# CONSERVATION COMMISSION AGENDA

August 26, 2021

- Request: Issue an OOC.
3. **(7:25) Levingston Cove (Crystal lake) – NOI – park improvements – DEP File #239-901**
  - Owner: City of Newton Applicant: Luis Perez Demorizi, Open Space Coordinator

Issued For:  
**PERMITTING SET**  
 - NOT FOR CONSTRUCTION -

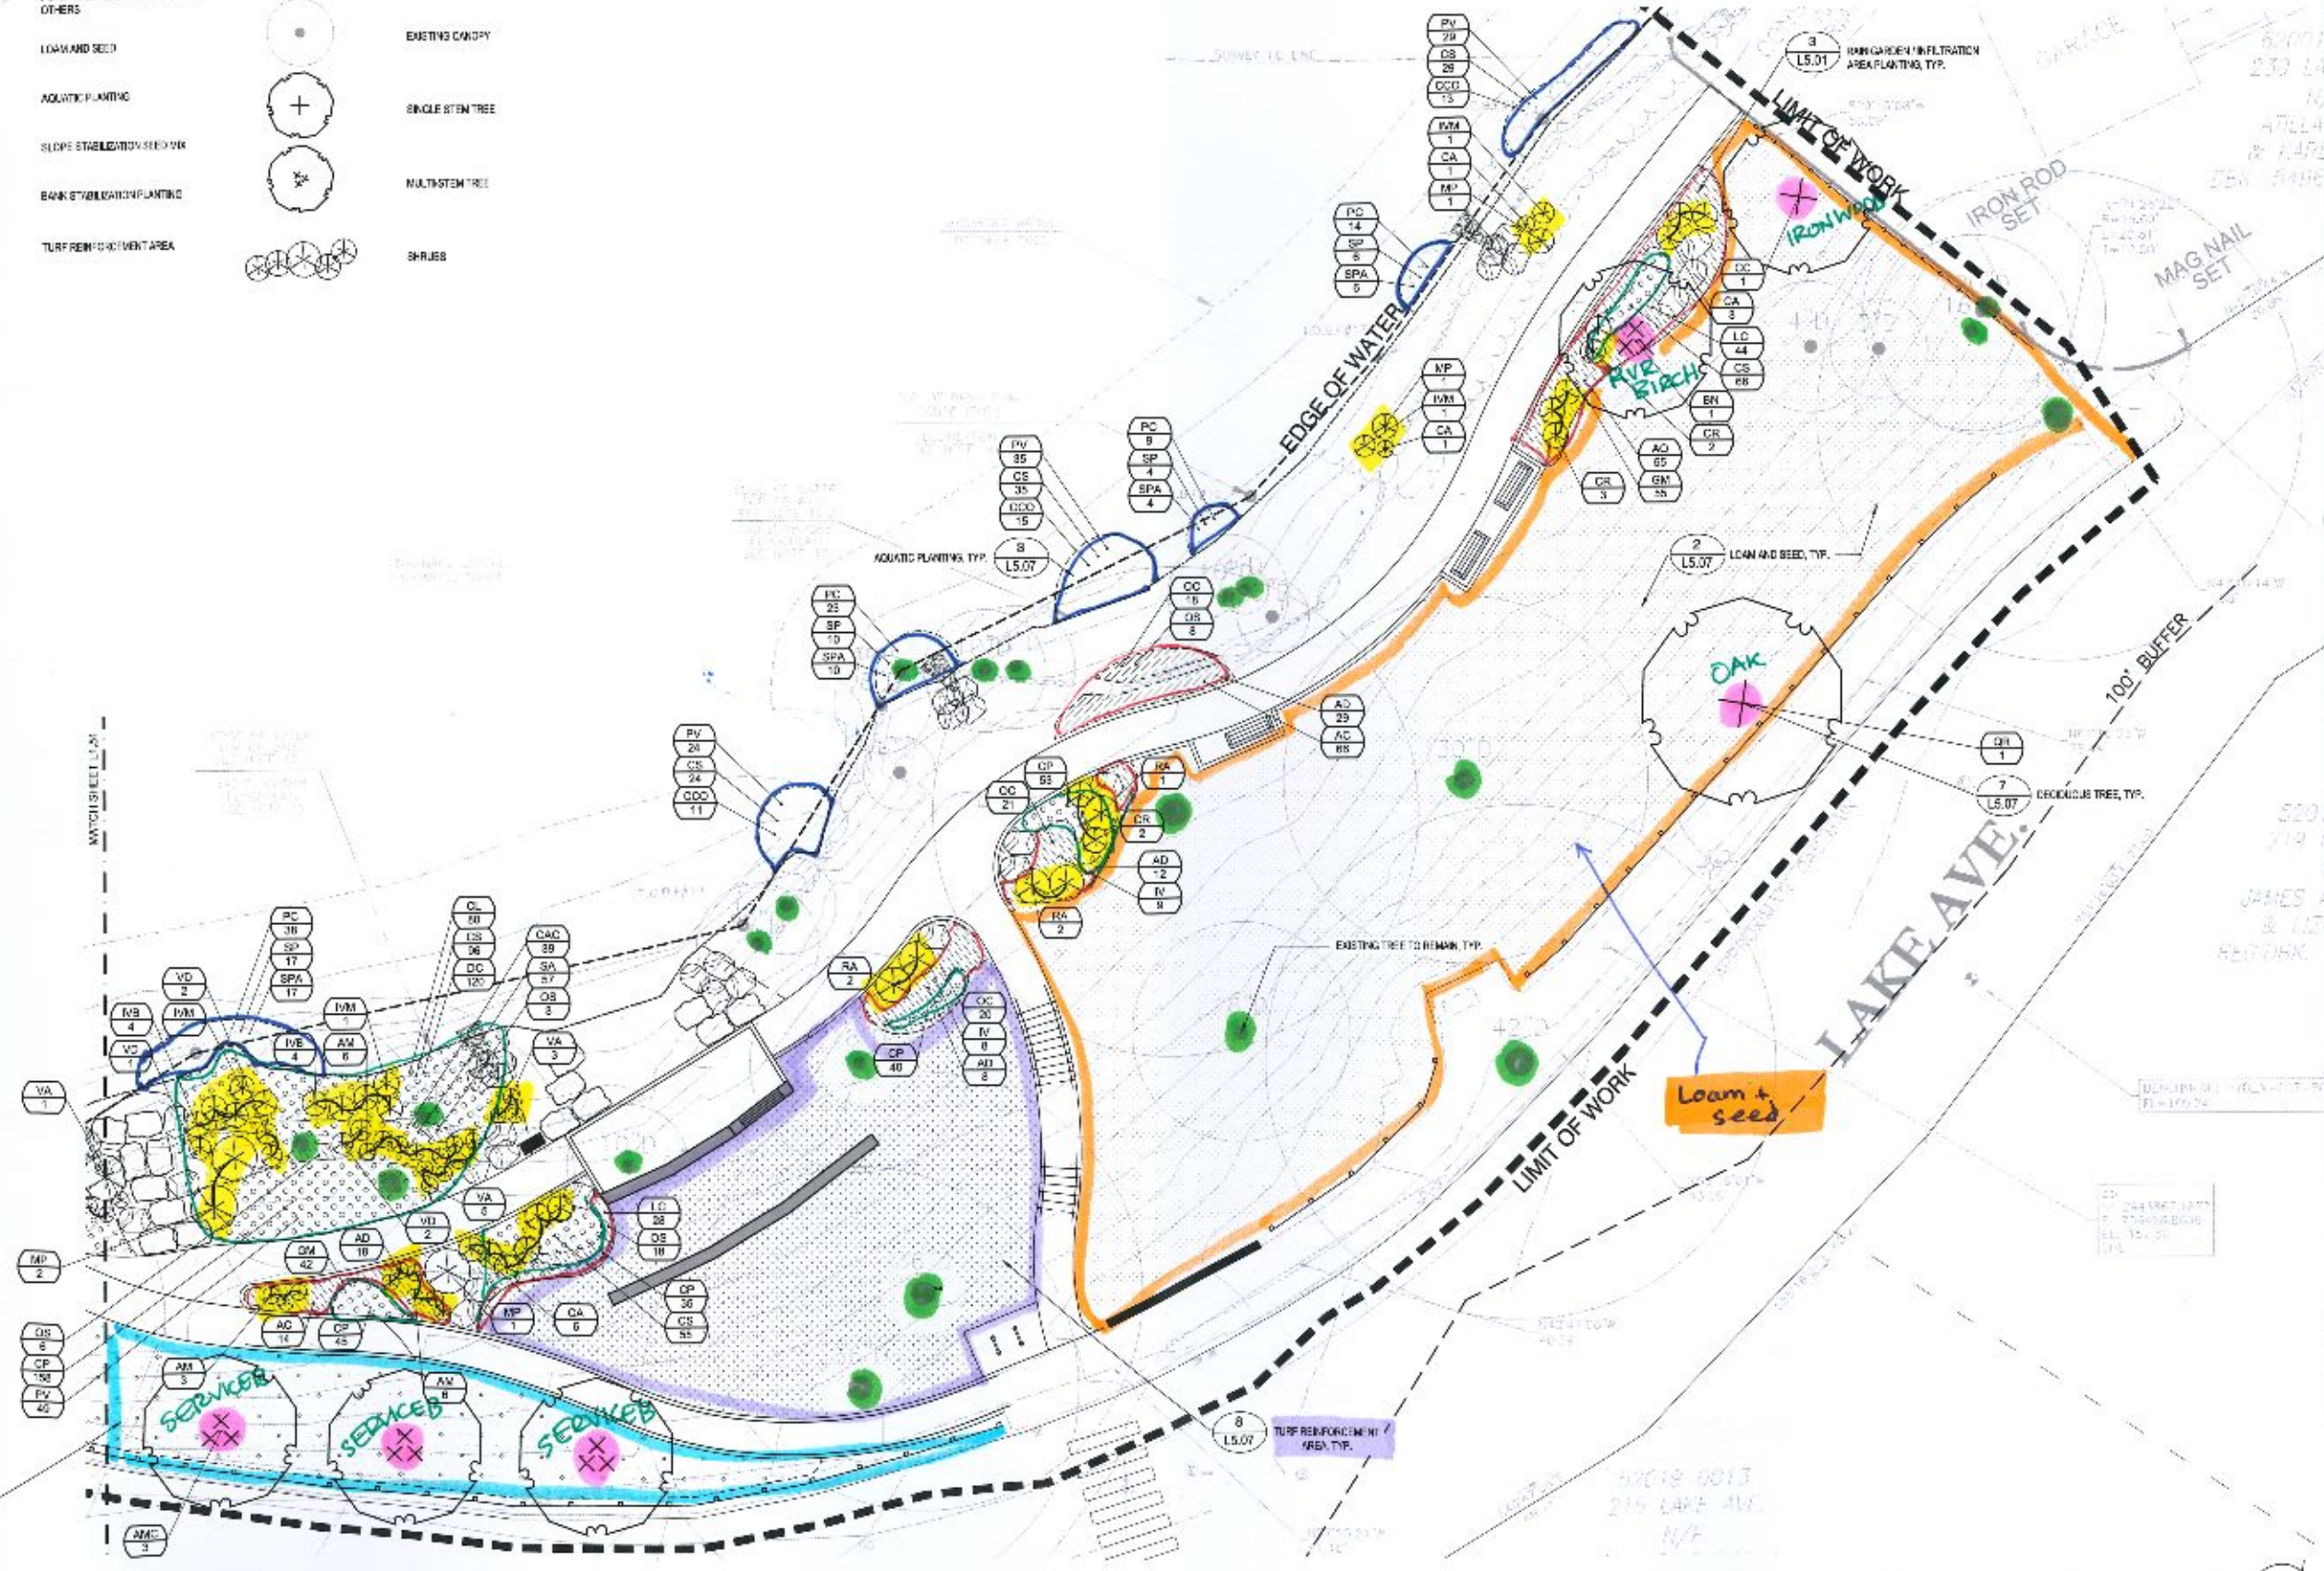
- In the narrative (and on the plans, as appropriate) the applicant should expand descriptions of anticipated processes such as:
    - Excavation
    - Stockpiling

- The applicant should clarify:
    - chapter 91 status,
    - anticipated timing of the work,
    - what work is proposed in the BVW (L1.11), and
    - tree protection (L1.11 and L5.00).

- What the "add alt – cofferdam with sandbags" (L1.10) pertains to? (stone veneer work?)
- What treatment methods and timing are planned for invasive species removal?

- What "synthetic turf reinforcement material" (narrative pg 2) is? (the 70-21-10 soil mixture?)
- Where the cross-sections A-D are located on the plan view?

- L5.07 – Turf Reinforcement detail. "tree mix"? (seed mix?) – please add the specs to the plan.
- S101 – "Section through pile cap" detail say "embed micropiles 6". Is that correct?

- S101 – is the cantilevered deck secured with bolts, not "deadmen"?
- Suggested plan and narrative changes:
  - Change in the narrative and L1.10 "straw wattles" to "staked silt fence and staked compost sock"

- The narrative states (confusingly) that the City Floodplain is at 149'. It is, on the CNVD. But that is 142.5' NAVD88, the datum of the plans. Therefore, the cut and fill information in the narrative pages 4&5 is inaccurate.

- Add cofferdam details.
  - Add the Turf Reinforcement specs to the plan.
  - Add dewatering information.
  - Add stockpiling locations.
- Staff Recommendations: Await responses to staff notes (and Commissioners' questions).

Tree Removal Plan

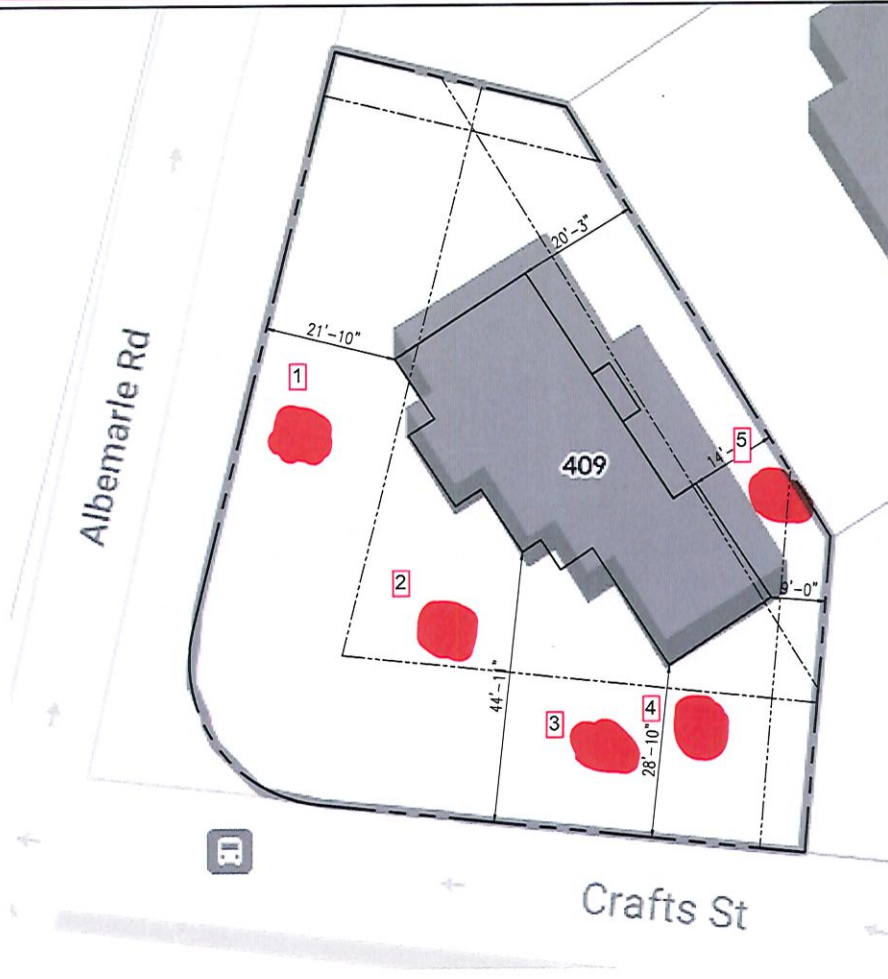
- Staff are concerned that separating the permitting of mitigation planting from the permitting of tree removal sets a bad precedent.
- Staff feel that until an NOI is submitted, the request to remove trees must be considered on its own – therefore any required mitigation must be considered at this point in time.

- Staff have concerns about how a lot this small will be able to support the anticipated replacement plantings for the proposed tree removal, especially without an understanding of what expansion/renovations will be proposed to the house itself.

- There are three mature trees on the lot the applicant is not proposing to remove. These trees should be protected during any tree removal activity on site to ensure there is no confusion in what trees are to be removed.

- If the applicant does not wish to provide a mitigation plan and install mitigation plantings immediately following tree removal, the Commission may wish to require an NOI for the intended tree removal and construction project.

○ Staff Recommendations: If appropriate, vote to issue negative 3 Determination of Applicability for the removal of trees 1, 2 and 5 with the following special conditions – DOA to be held until a mitigation planting plan has been received by the Conservation Office and approved by Conservation staff.
